Drawing Title: **PROPOSED SOUTH WEST AND SOUTH EAST ELEVATIONS**

Job Title: **Proposed Restoration and Re-building of Folly Bank, Woodside Farm, Yetholm, TD5**

Drawing Number: **812P2-09a**

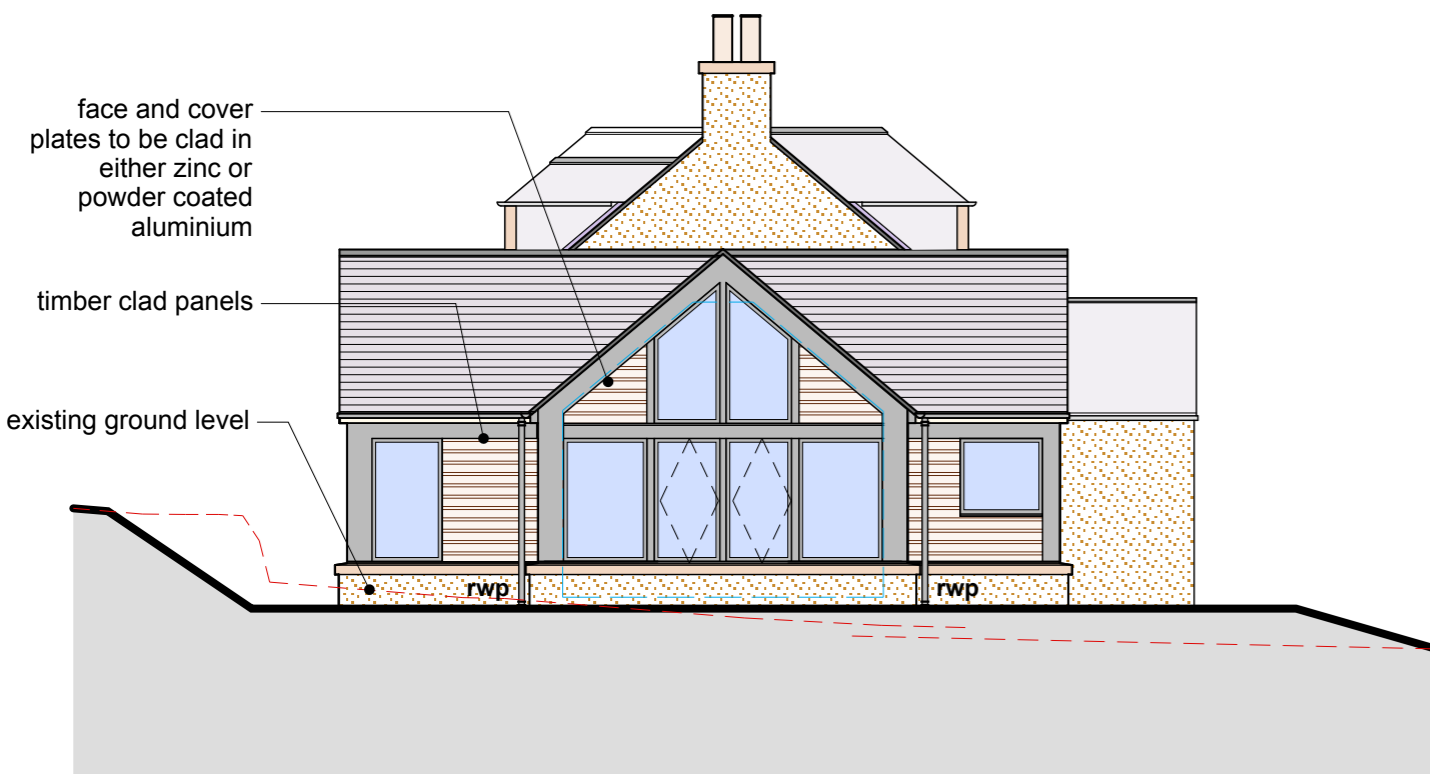
a) **13-05-19, Utility door now solid and swapped with window**
